MYSO, LLC  
Response to Siting Board Staff's Second Request for Information  
Case No. 2025-00395

Request No. 1:

**Received Sound Levels (Zoomed-B)**

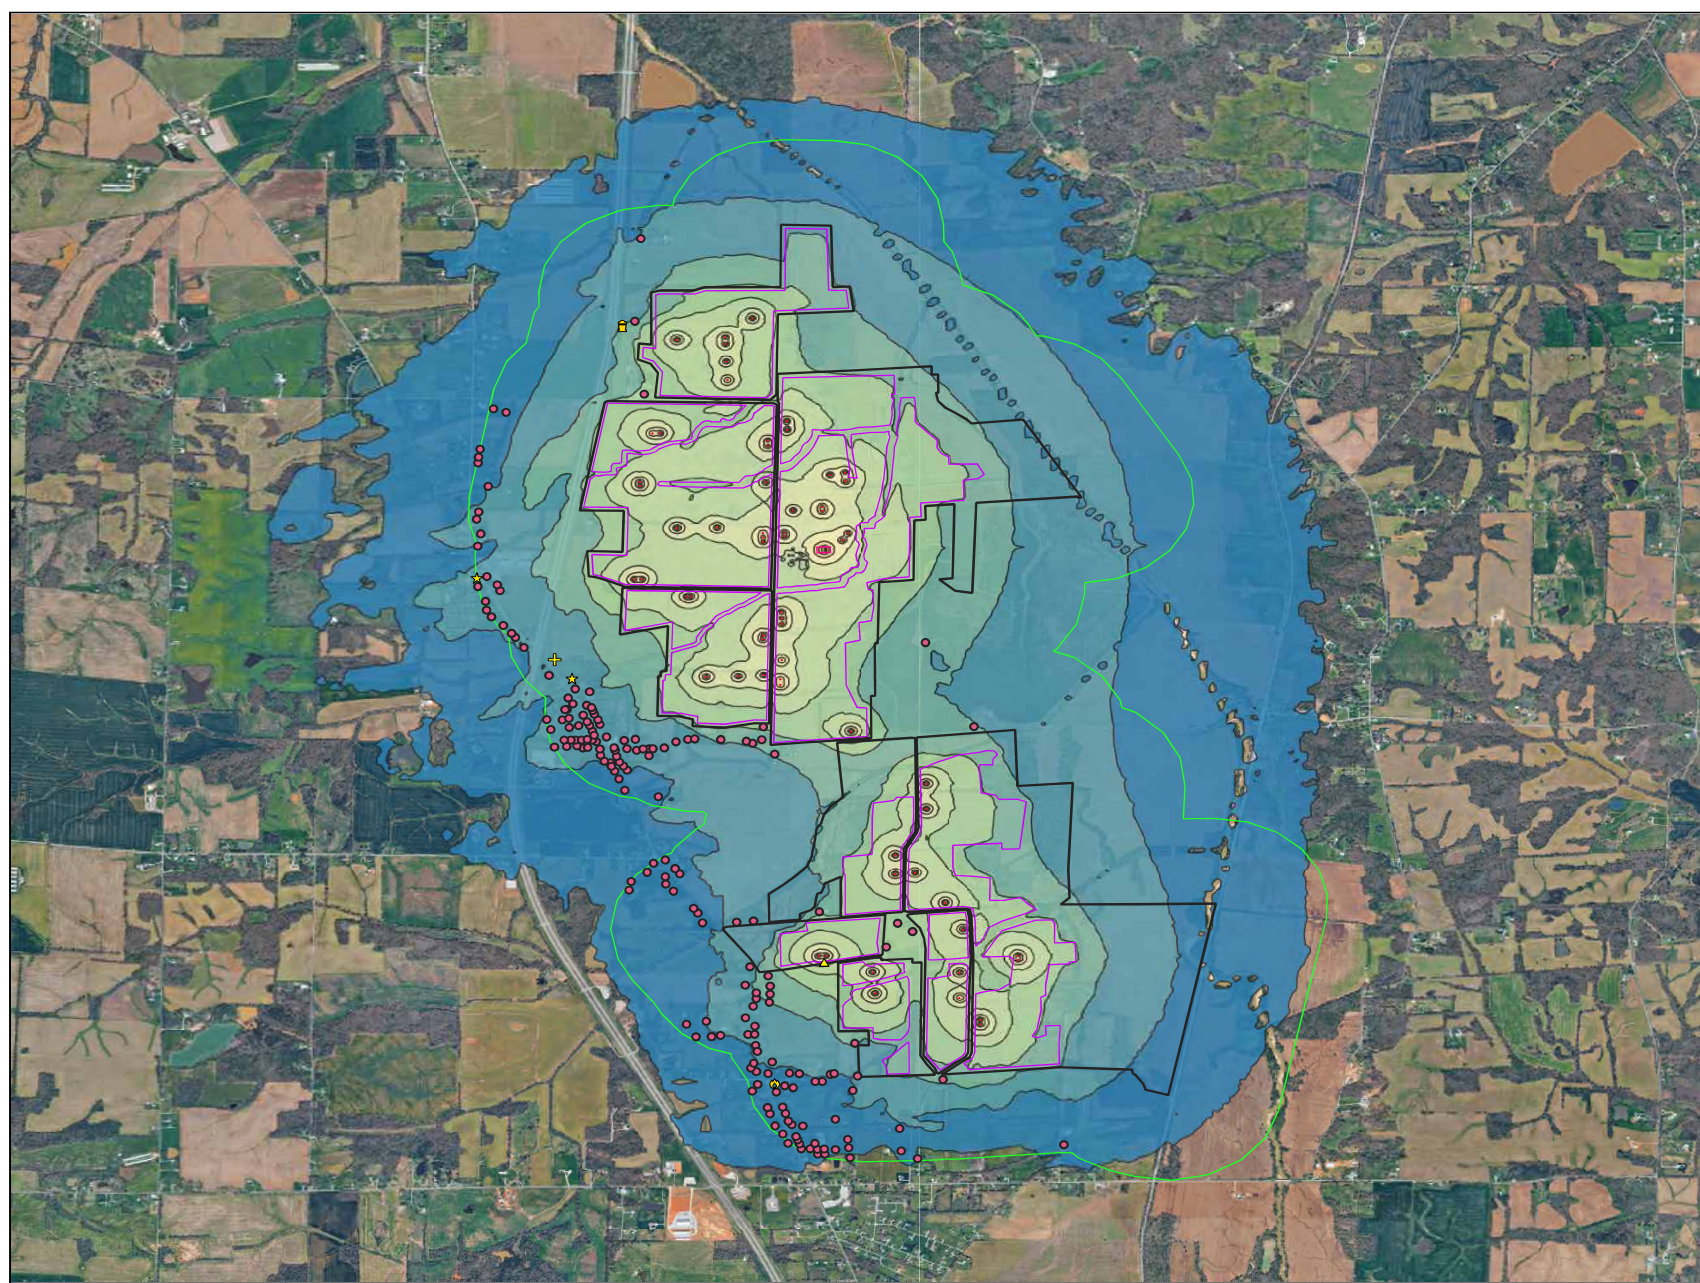
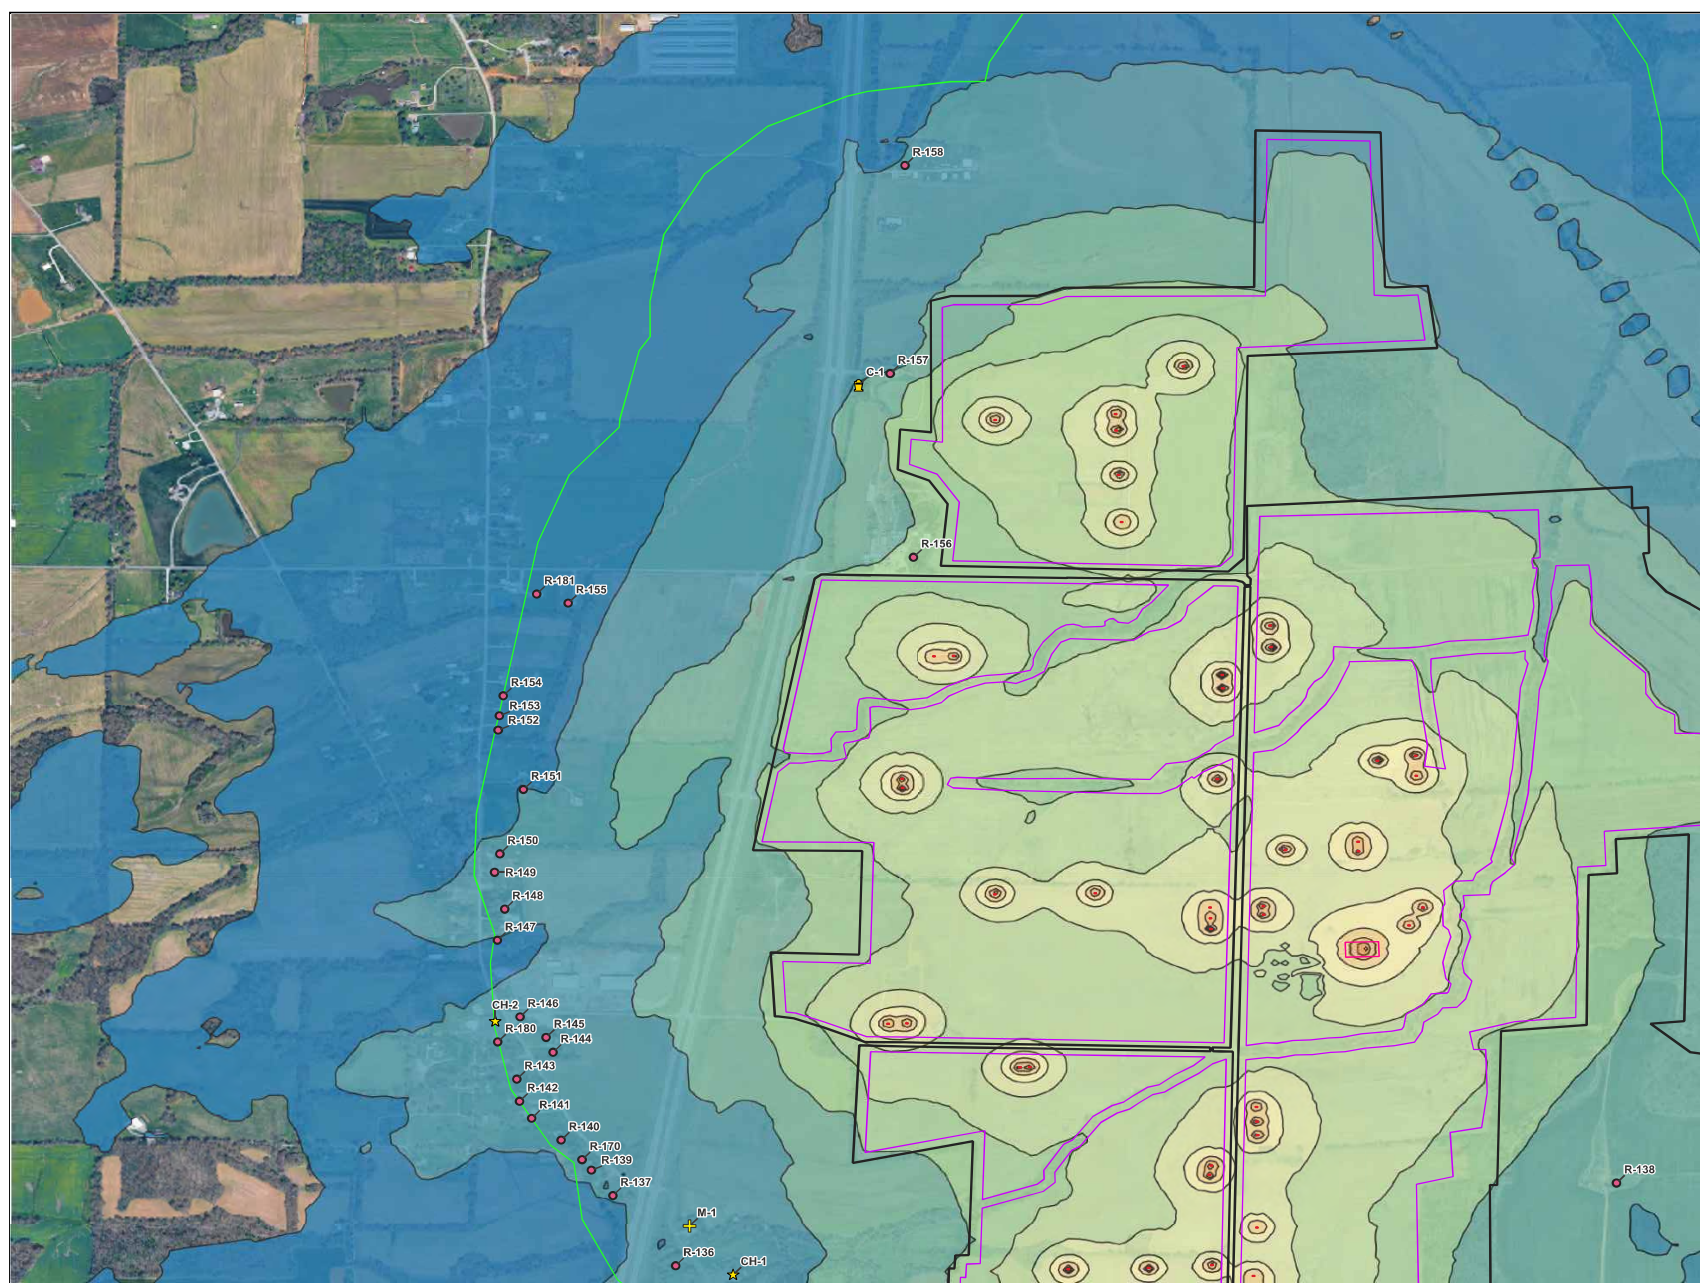
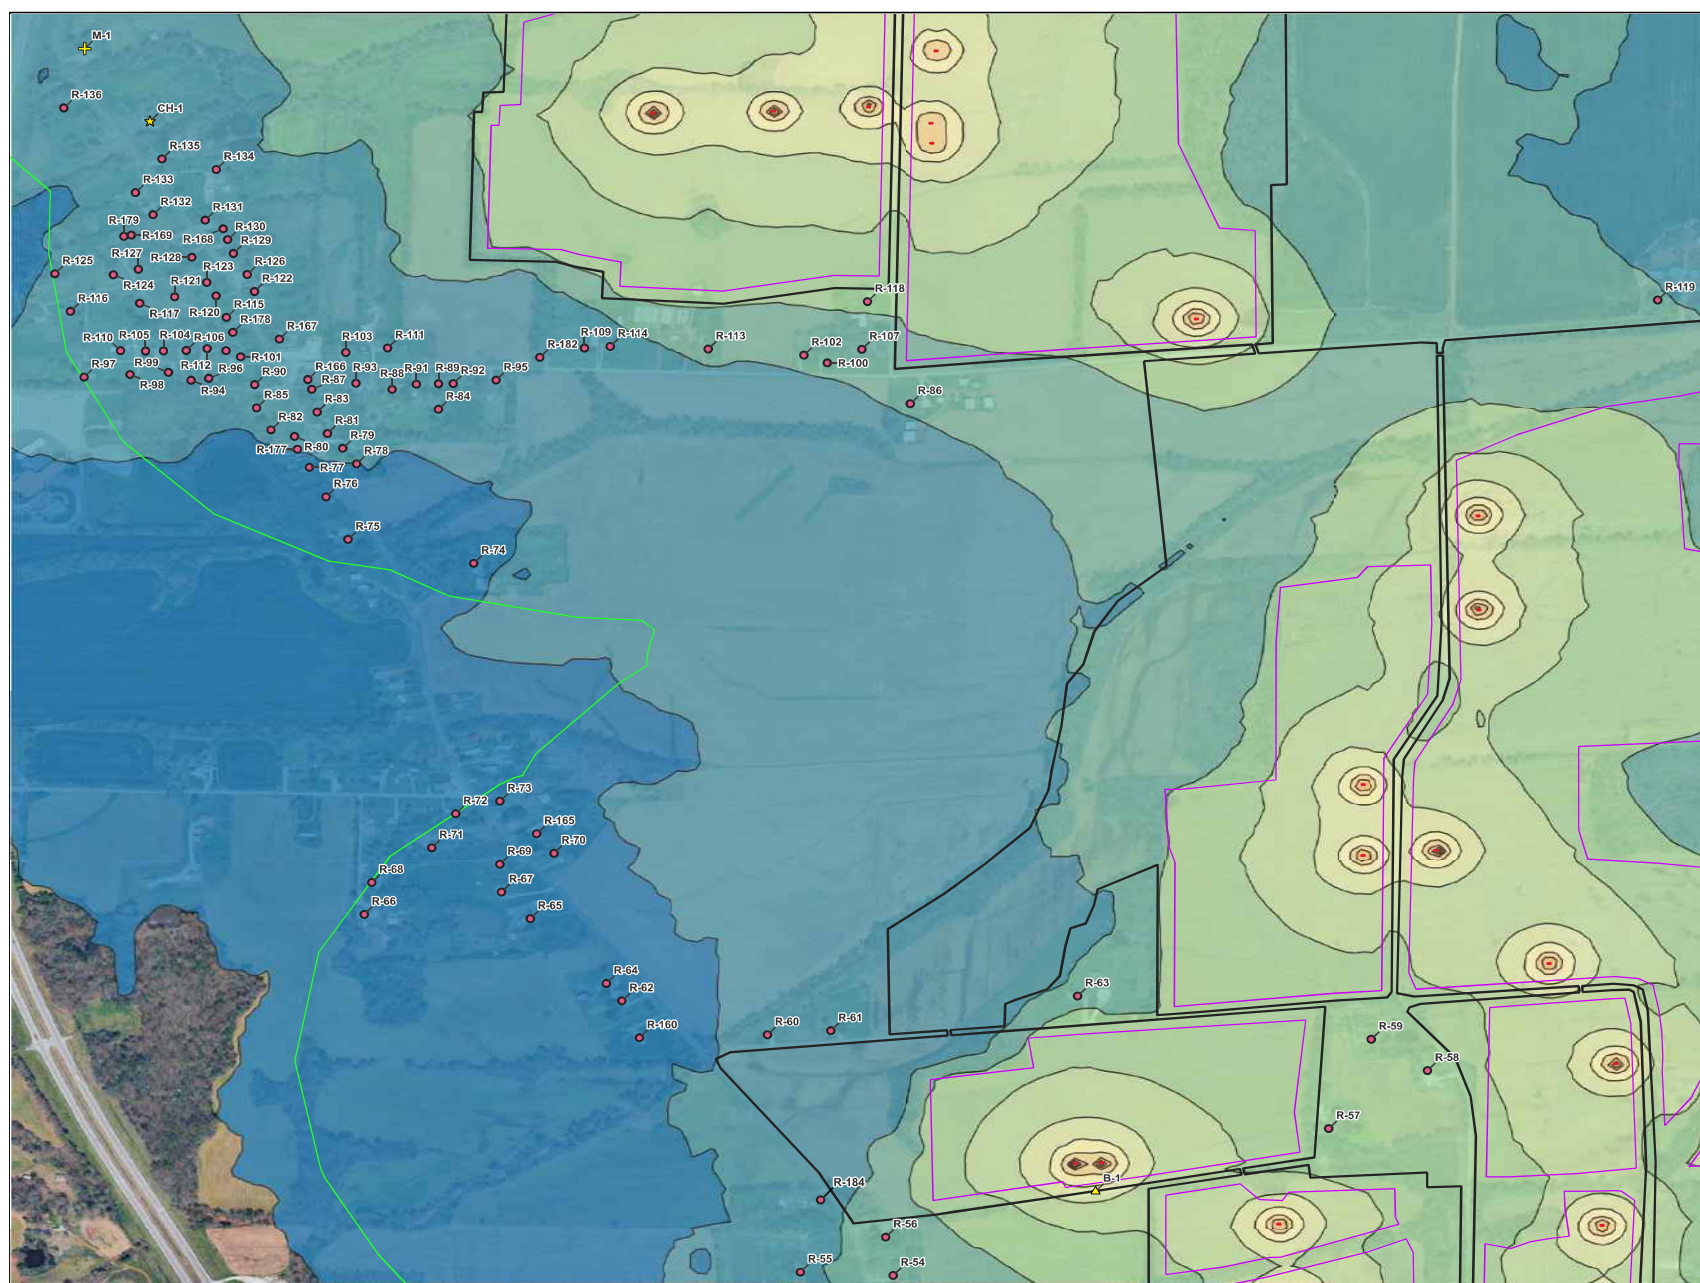
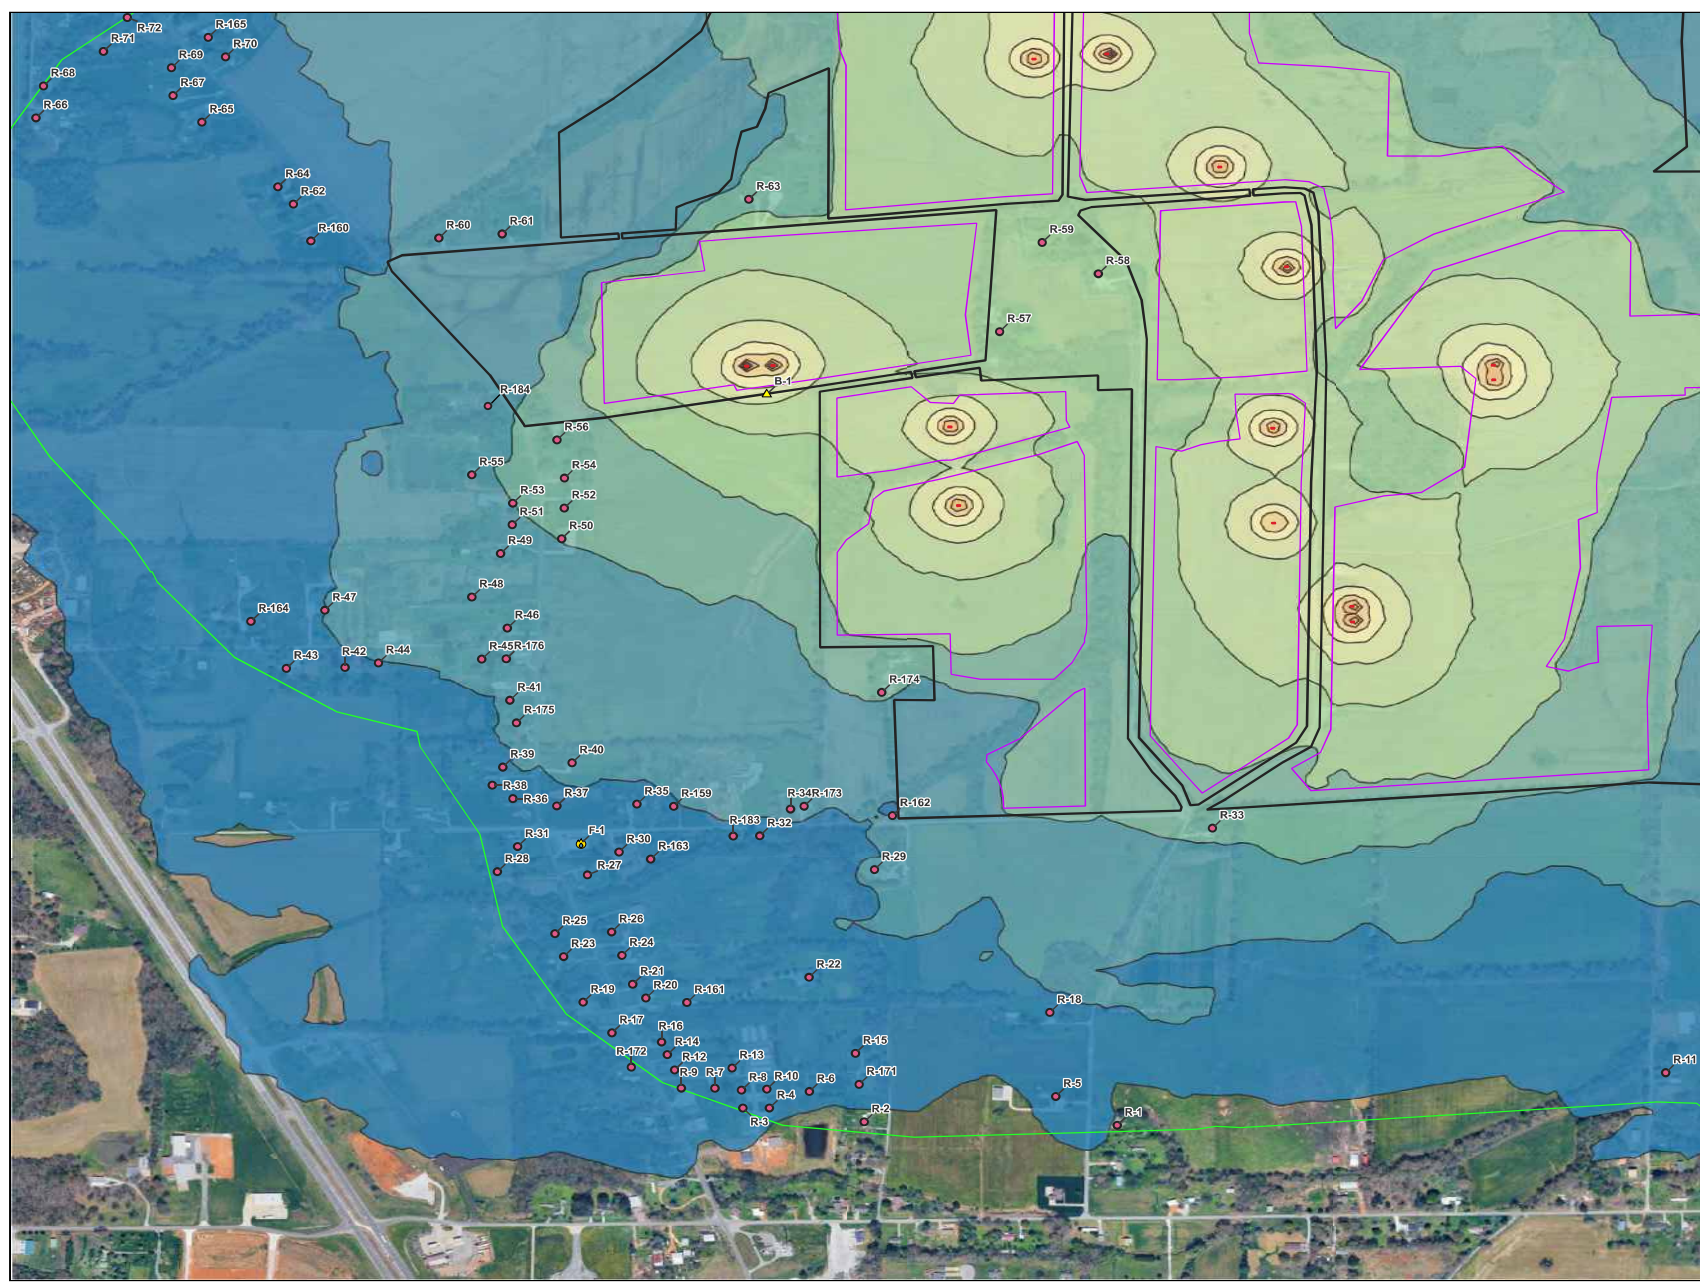
Refer to Application, SAR, Attachment D, Acoustic Analysis. Provide updated Figure-1 maps that reflect the revised list of Residential Structures from MYSO's response to Staff's First Request, Item 7. Include the following receptors on the updated maps that are not included in the "Residential Structures Within 2,000 Feet" Table: R-166, the omitted residence located at 5601 KY-1204, CH-1, CH-2, F-1, M-1, and C-1.

Please see the map set attached hereto and the tables attached to Response Nos. 3 and 40. The referenced maps set and tables have been updated to include receptor R-166 and the omitted residence located at 5601 KY-1204, identified as R-184.
